Access Compliance Report

Public Rights-of-Way

Intersection ID: 10025452	Main Street: E_INDEPENDENCE_BV	Cross Street: N/A	Location: SW
ADA ID: C72DFA03E769	Ramp Type: Directional1	Initial Pass/Fail: Pass	Overall Compliance: No
		Severity Score: 0

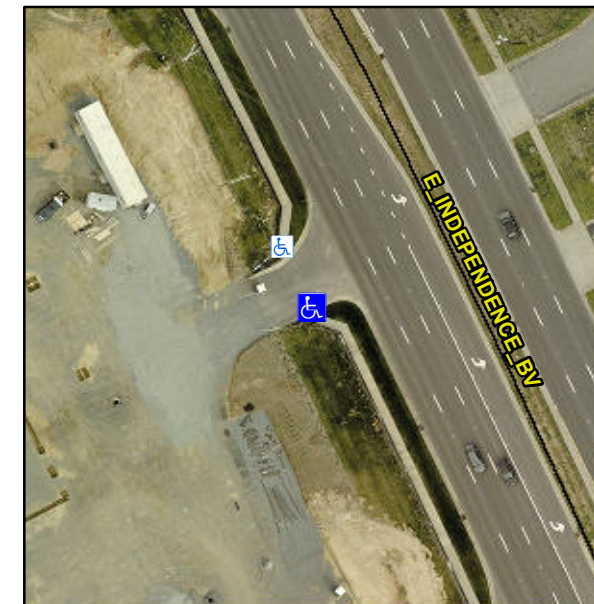
Not Found, R304.5.3, R305.2

Compliance	Description	Data	Compliance	Description	Data
N/A	Ramp Length (in)	45.0	Yes	Grade Break?	Yes
Yes	Ramp Width (in)	61.0	No	Grade Break Slope (%)	13.7
Yes	Ramp Slope (%)	4.5	Yes	Grade Break XSlope (%)	0.1
Yes	Ramp XSlope (%)	1.5			
N/A	Flare Type LT	N/A	N/A	Flare Type RT	N/A
N/A	Flare Slope LT (%)	N/A	N/A	Flare Slope RT (%)	N/A
N/A	Flare Traversable LT?	N/A	N/A	Flare Traversable RT?	N/A
Yes	Landing Length (in)	62.0	Yes	DWS Provided?	Yes
Yes	Landing Width (in)	59.0	Yes	DWS Contrast?	Yes
Yes	Landing Slope (%)	1.0	Yes	DWS Length (in)	24.0
Yes	Landing X Slope (%)	1.4	Yes	DWS Full Width?	Yes
N/A	Landing Curb? (Y/N)	No	No	DWS Offset LT (in)	2.5
N/A	Shared Landing?	No	Yes	DWS Offset RT (in)	6.0
Yes	Gutter Ponding?	No	Yes	Gutter Slope (%)	1.1
Yes	Gutter Lip Ht (in)	0.0	Yes	Gutter X Slope (%)	1.4
N/A	Painted X Walk1?	No		Road Slope (%)	3.6
	X Walk 1 Direction	To NW		Road X Slope (%)	1.6
	X Walk 1 Width (in)	N/A		Clear Space?	Yes

Remove & Replace Entire Ramp.
